MONROE COUNTY, NEW YORK

ADDENDUM NO. 2

**MONROE COMMUNITY COLLEGE
2011 WINDOW REPLACEMENT AND CONCRETE/BRICK REPAIR
DECEMBER 2010
Bids Due: January 6, 2010 at 2:00 PM,**

Prepared by:
DeWolff Partnership Architects LLP
151 St. Paul Street
Rochester, New York 14604

3 THIRD FLOOR PLAN- WINDOW REPLACEMENT & CONCRETE REPAIR
1/16" = 1'-0"

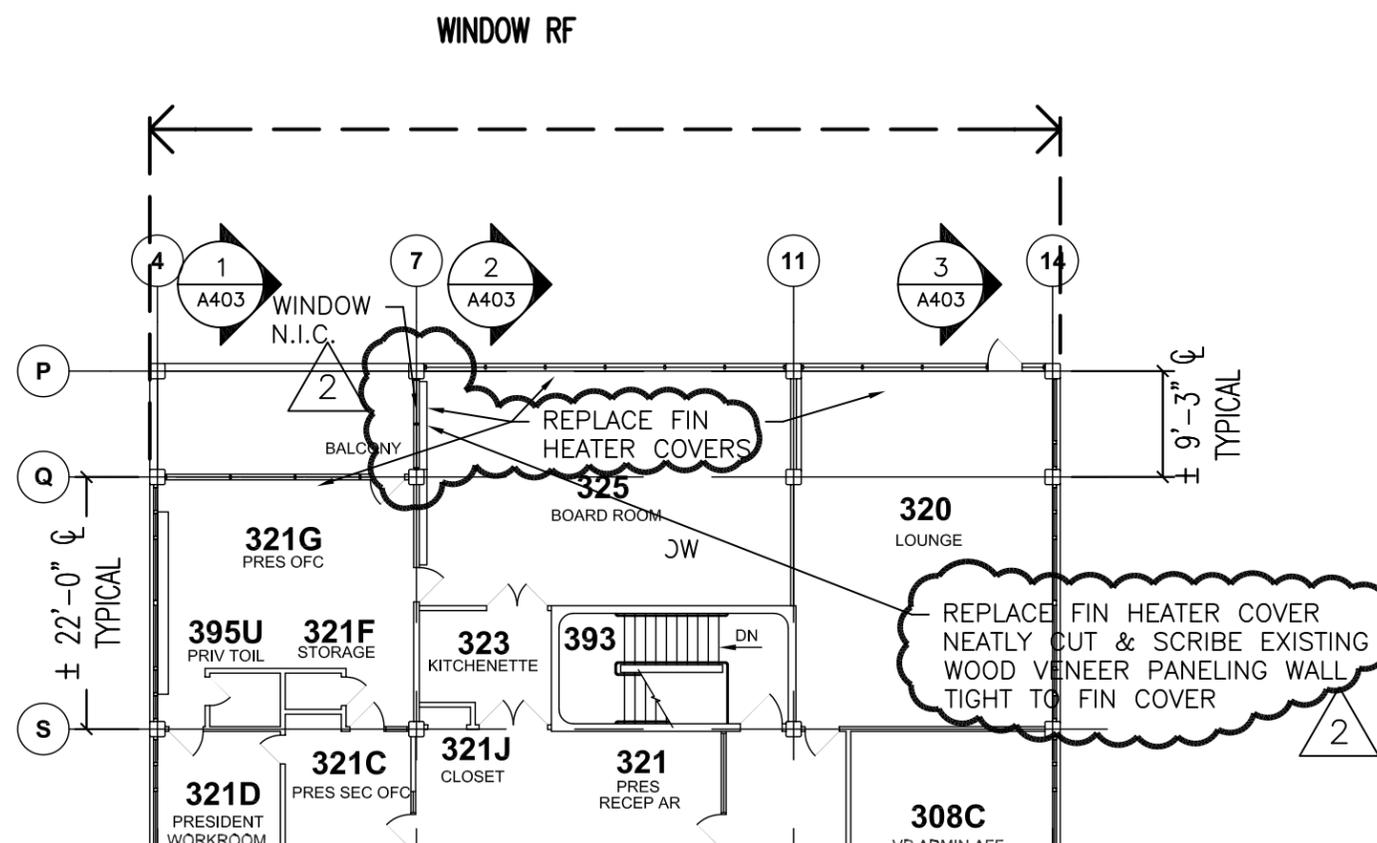
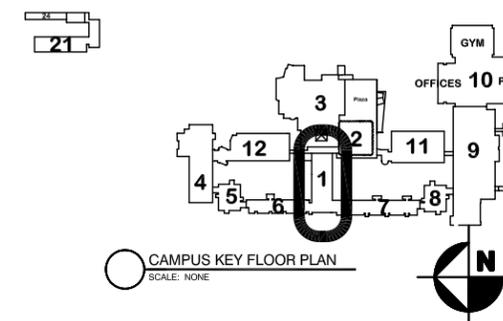
2-3 Third Floor Plan 3/A-101:

ADD: REPLACE PARTIAL EAST THIRD FLOOR PLAN WITH ATTACHED PARTIAL EAST THIRD FLOOR PLAN AS FOUND ON ADDENDUM 2, DRAWING 1-29, REVISION 2-3.

1-86 REV 2-10

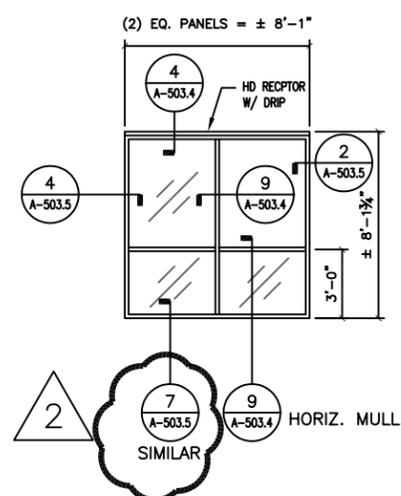
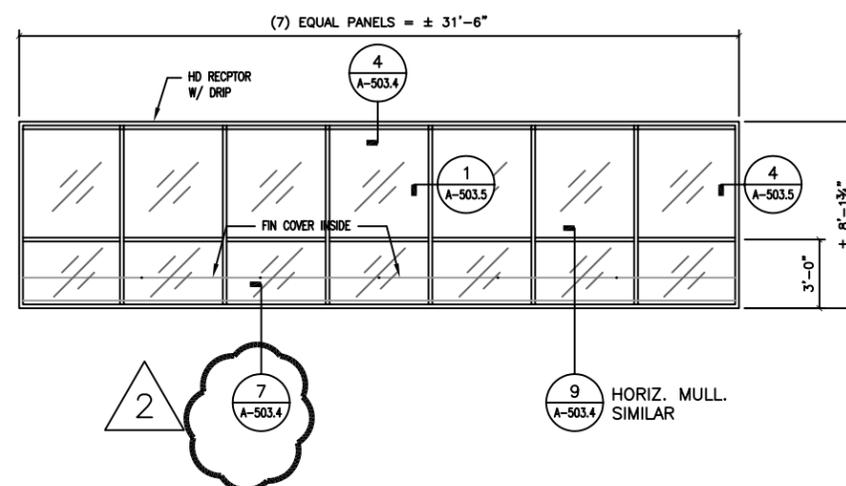
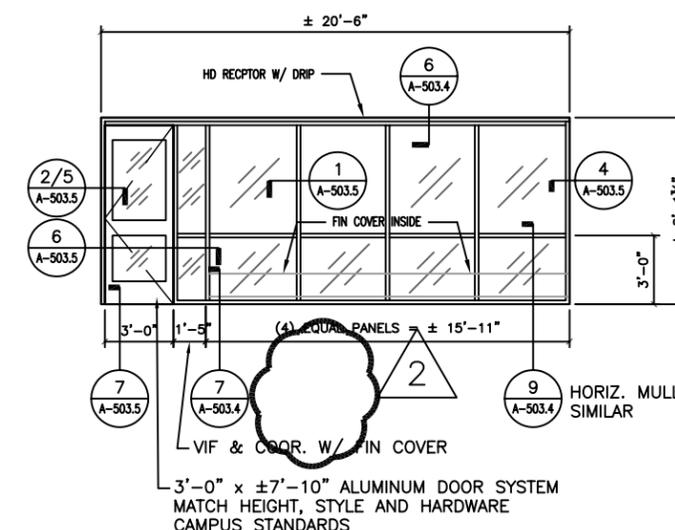
2-10 Window Types 1F, 1G and 1H:
ADD: REPLACE WINDOW TYPES 1F, 1G AND 1H/A-303 WITH ATTACHED WINDOW TYPES 1F, 1G AND 1H AS FOUND ON ADDENDUM 2 DRAWING 1-86, REVISION 2-10.

1-88 REV 2-11

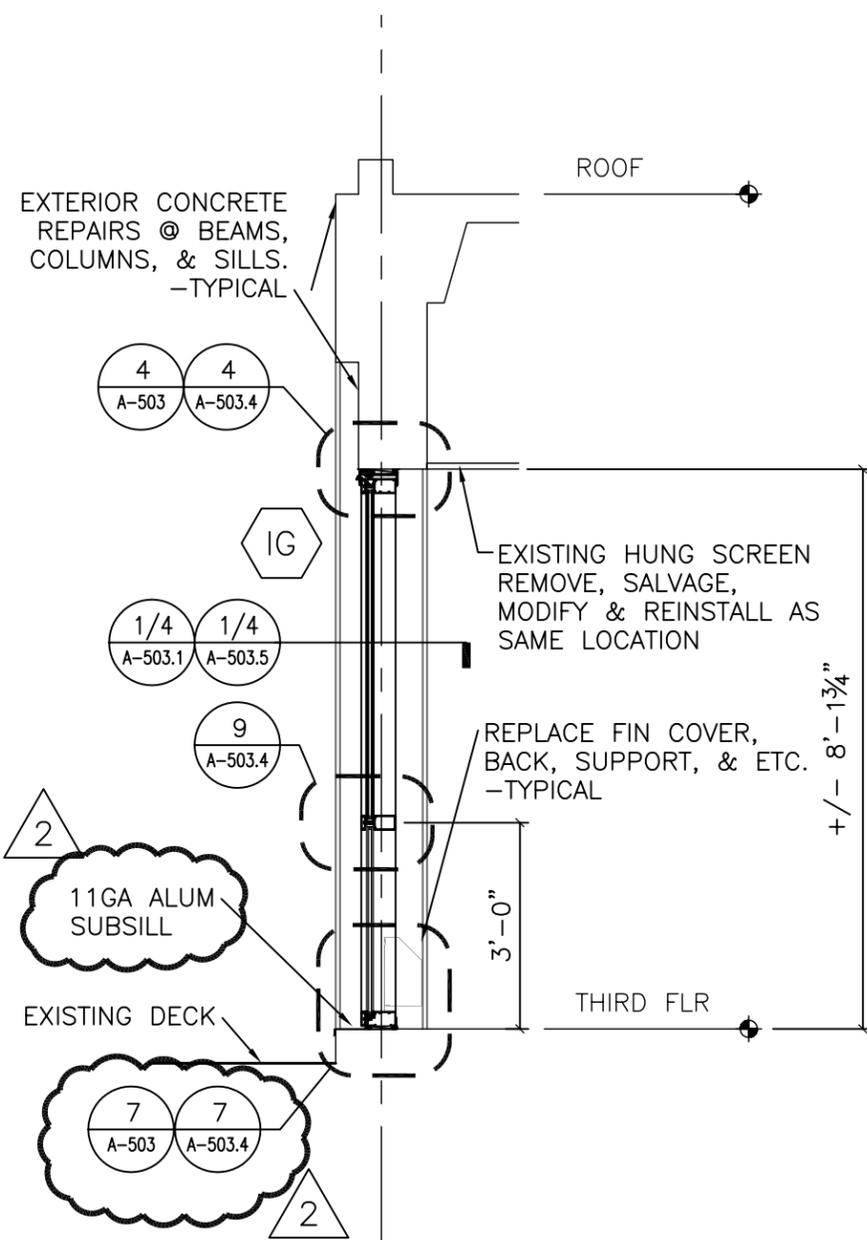
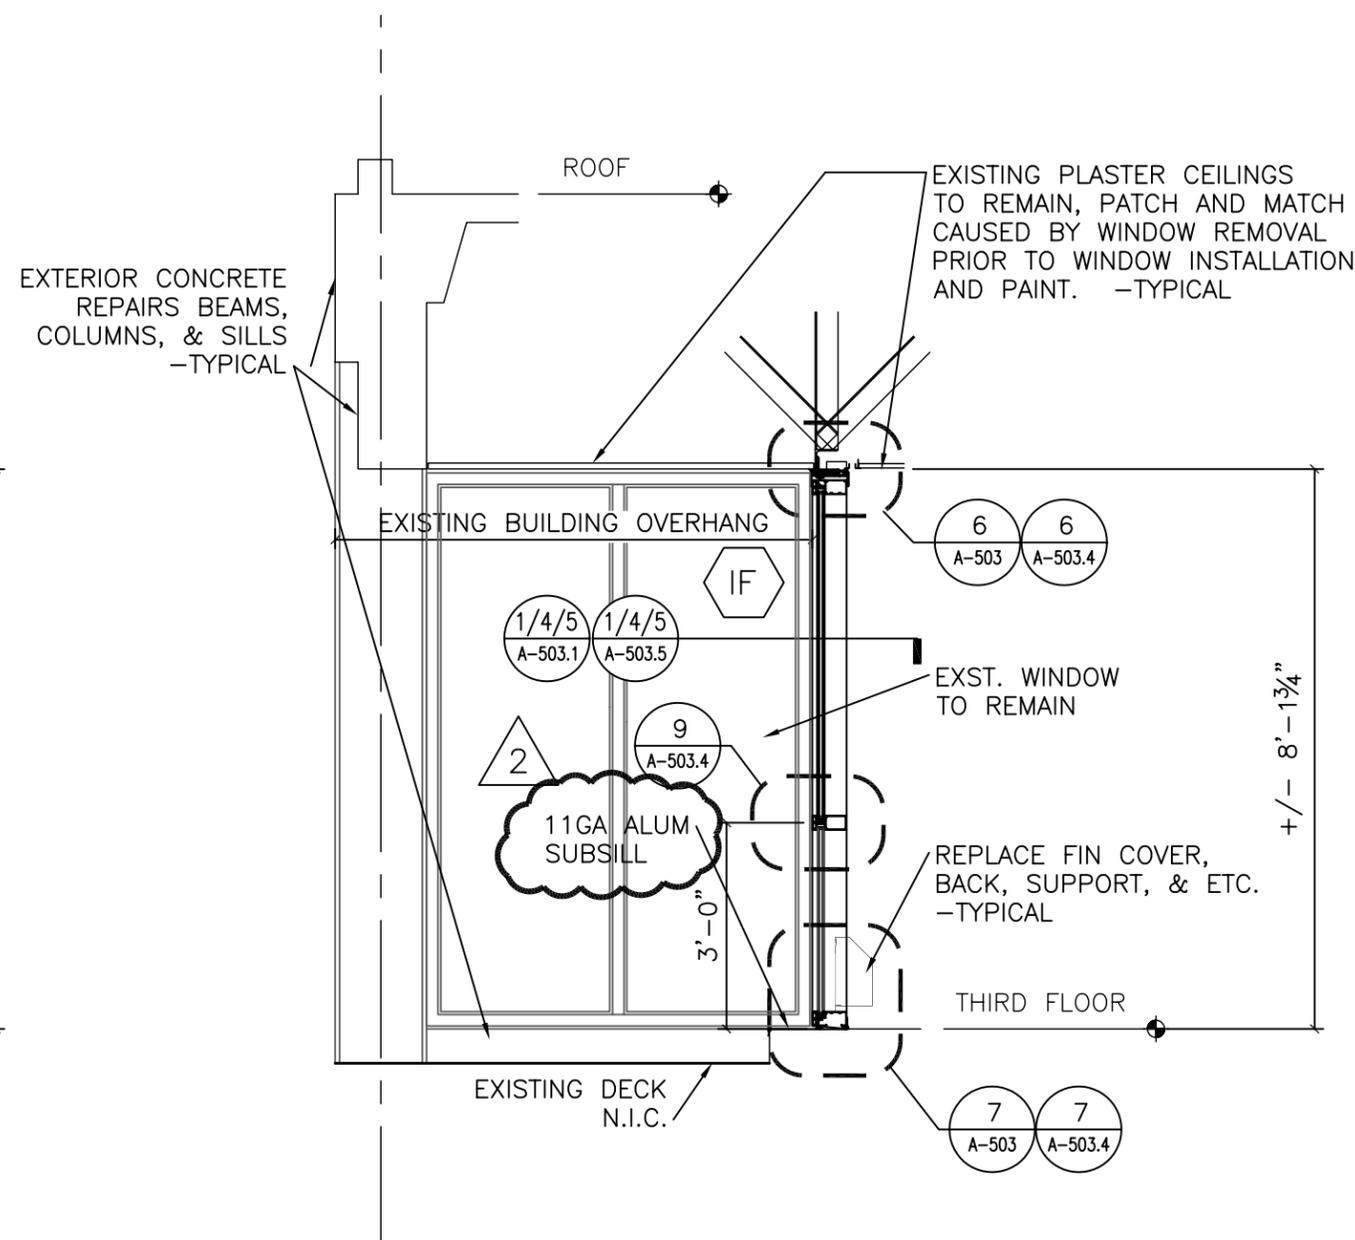
2-11 Partial Wall Section 1 & 2/A-403:
ADD: REPLACE PARTIAL WALL SECTIONS 1 & 2/A-403 WITH ATTACHED PARTIAL WALL SECTIONS 1 & 2 AS FOUND ON ADDENDUM 2 DRAWING 1-88, REVISION 2-11.

1-89 REV 2-12

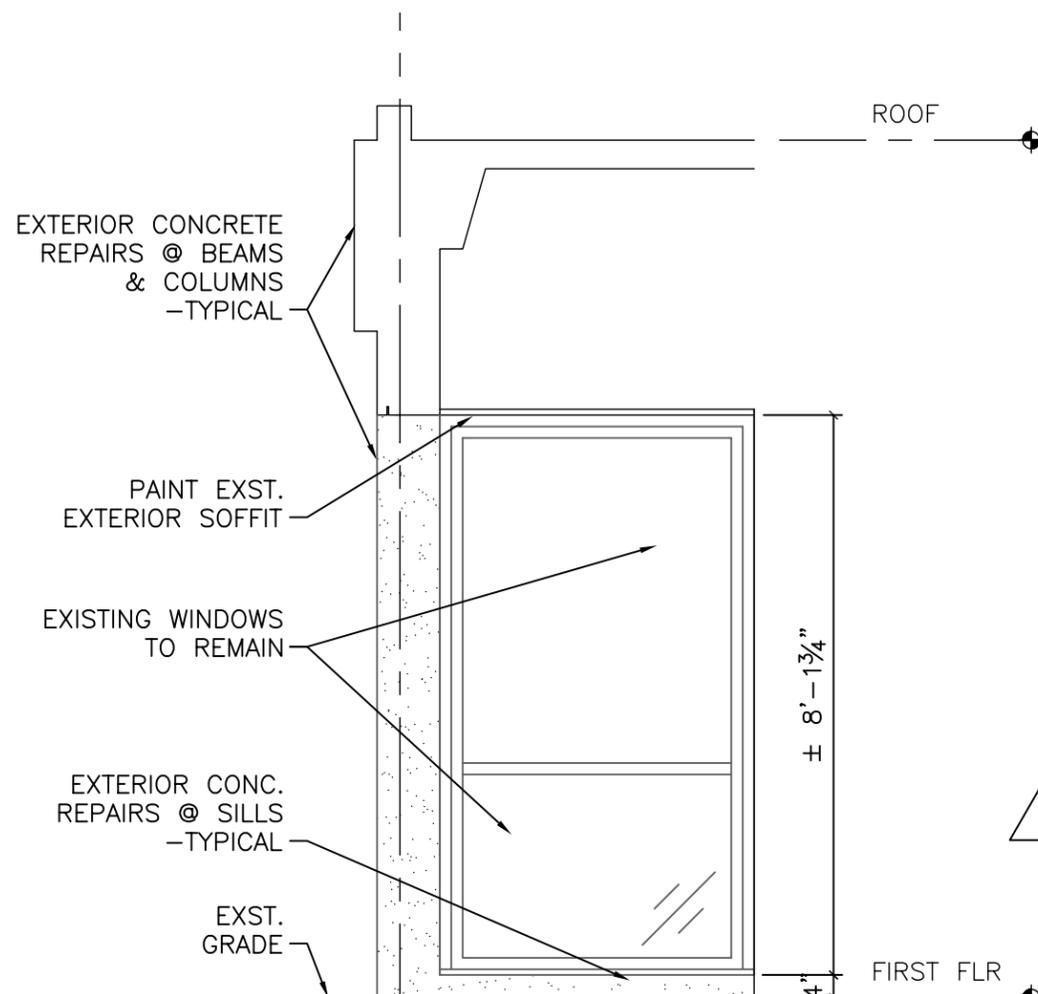
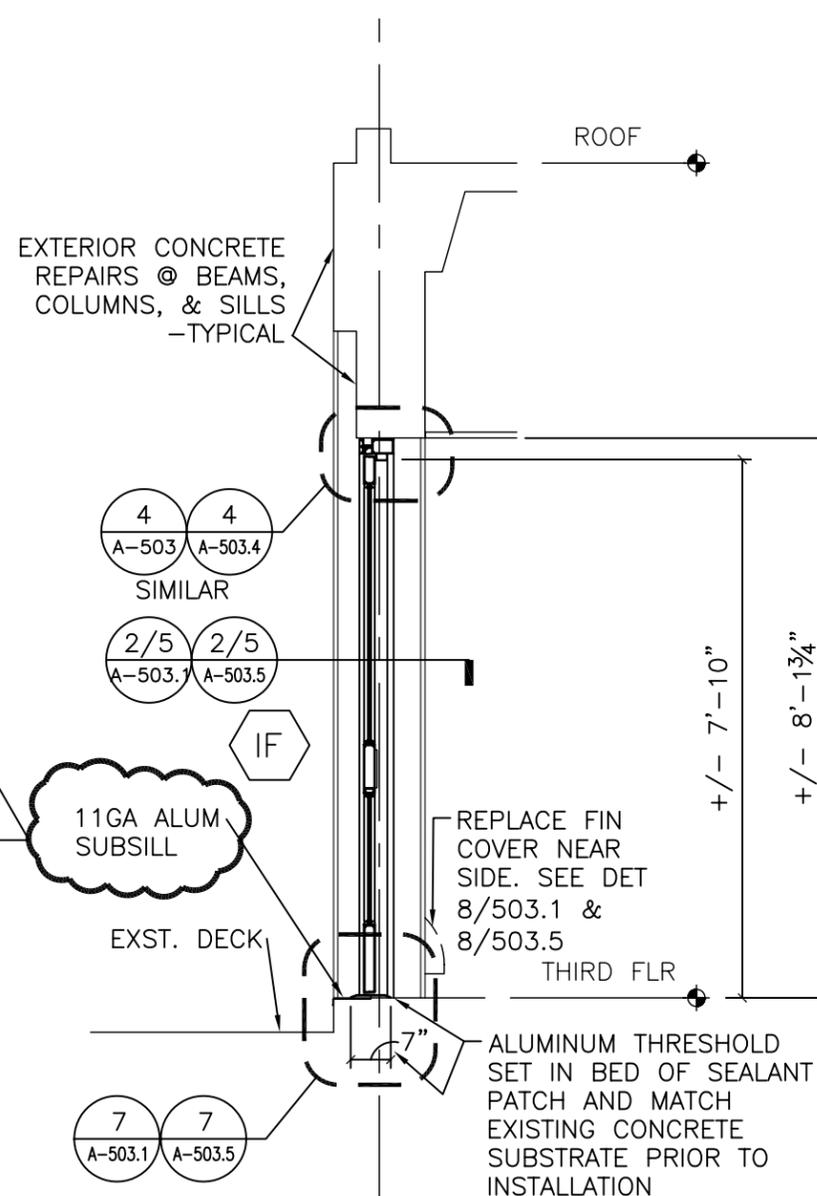
2-12 Partial Wall Section 3 & 4/A-403:
ADD: REPLACE PARTIAL WALL SECTIONS 3 & 4/A-403 WITH ATTACHED PARTIAL WALL SECTIONS 3 & 4 AS FOUND ON ADDENDUM 2 DRAWING 1-89, REVISION 2-12.

1-91 REV 2-13

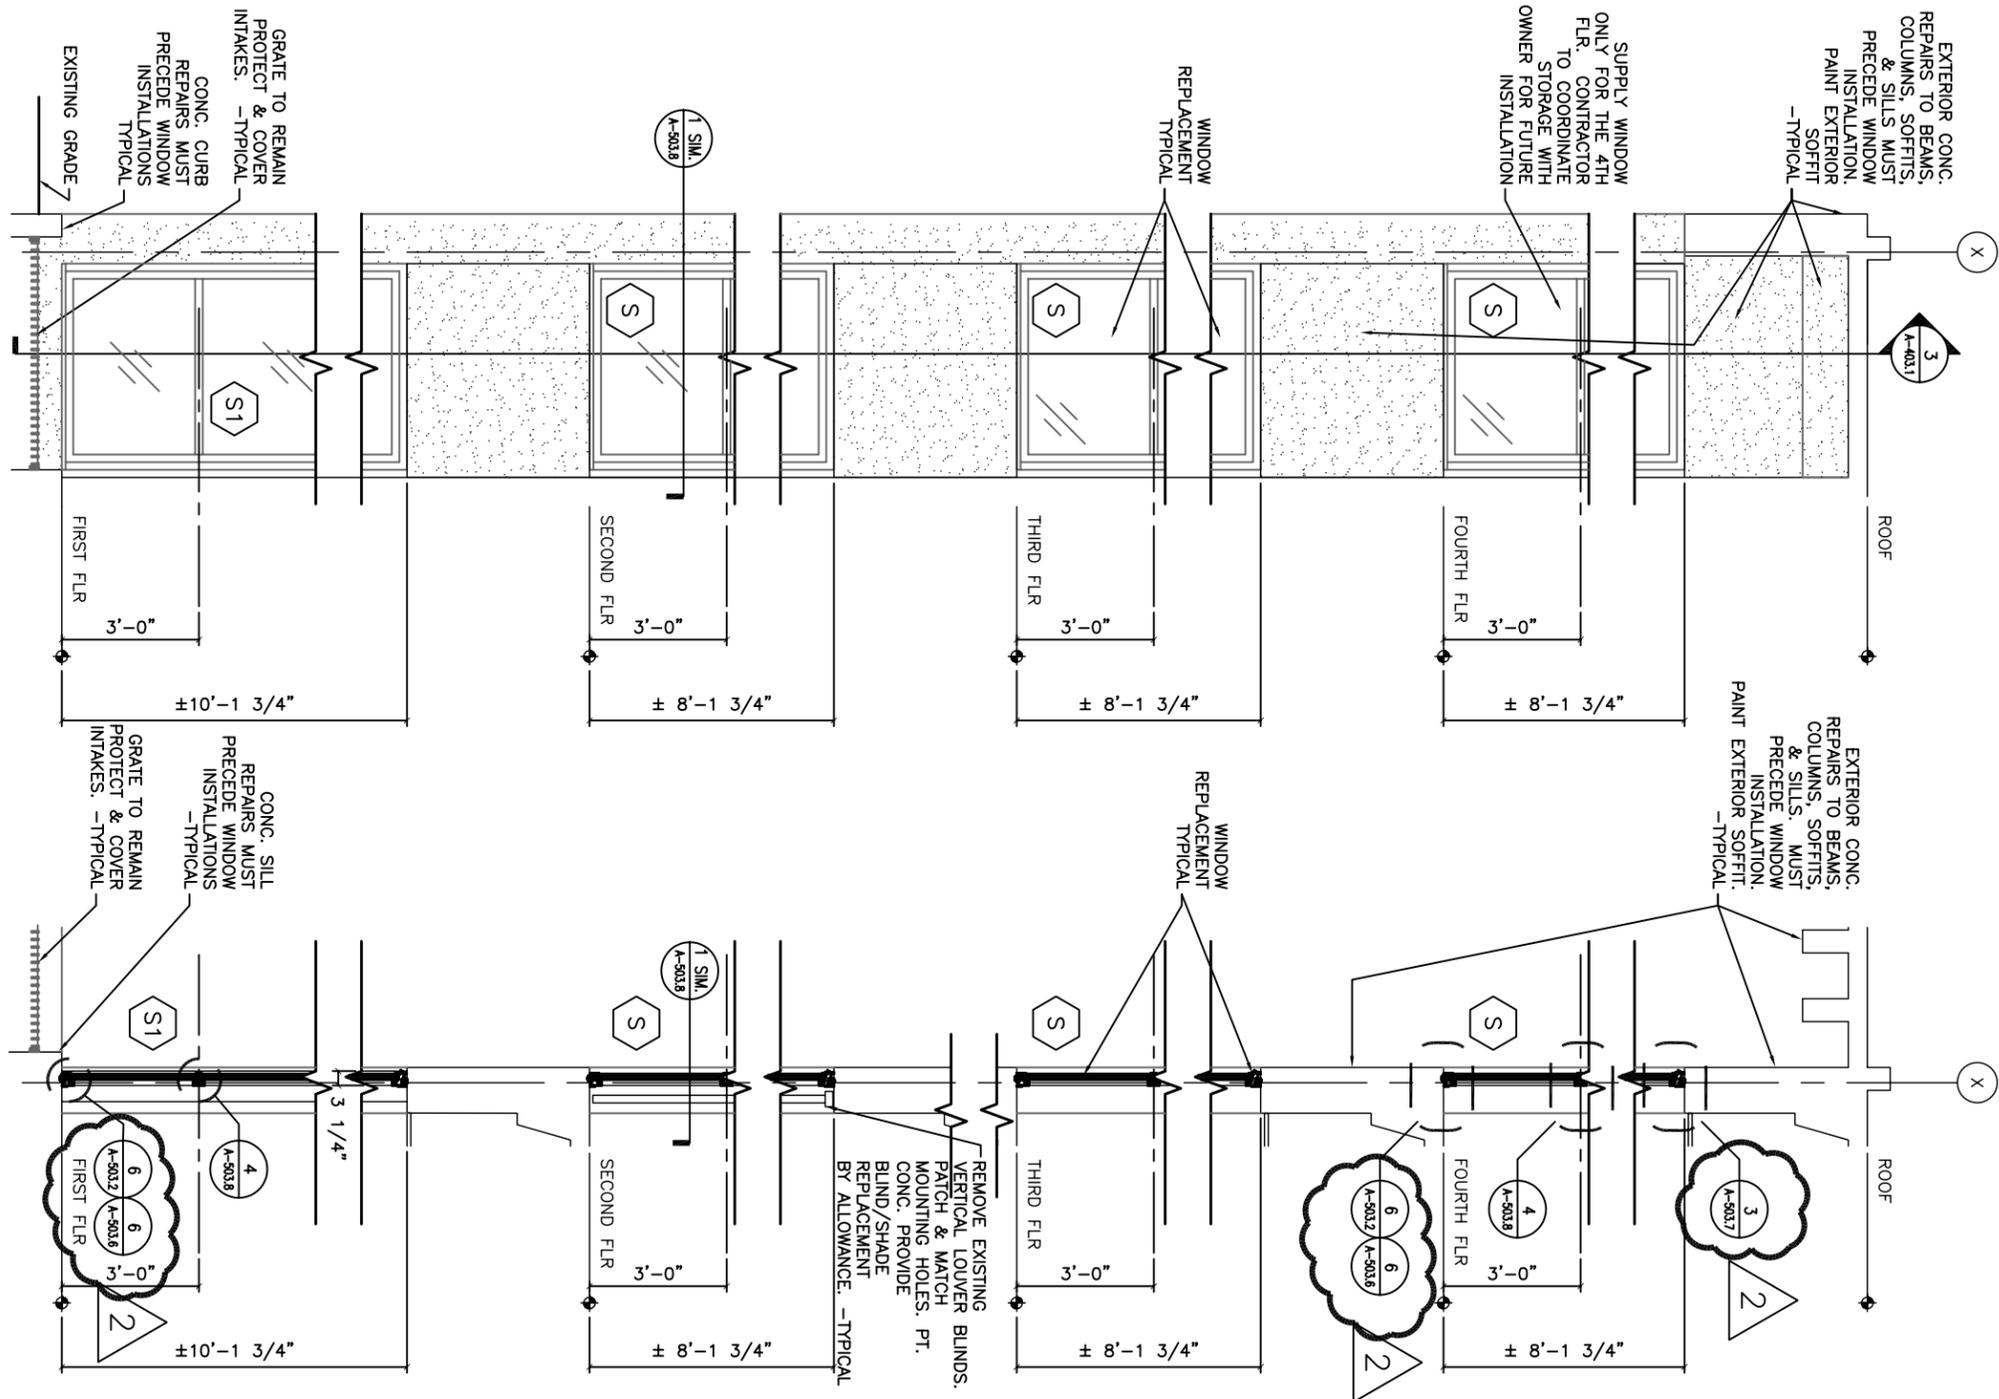
2-13 Partial Wall Section 3 & 4/A-403.1:
ADD: REPLACE PARTIAL WALL SECTIONS 3 & 4/A-403.1 WITH ATTACHED PARTIAL WALL SECTIONS 3 & 4 AS FOUND ON ADDENDUM 2 DRAWING 1-91, REVISION 2-13.
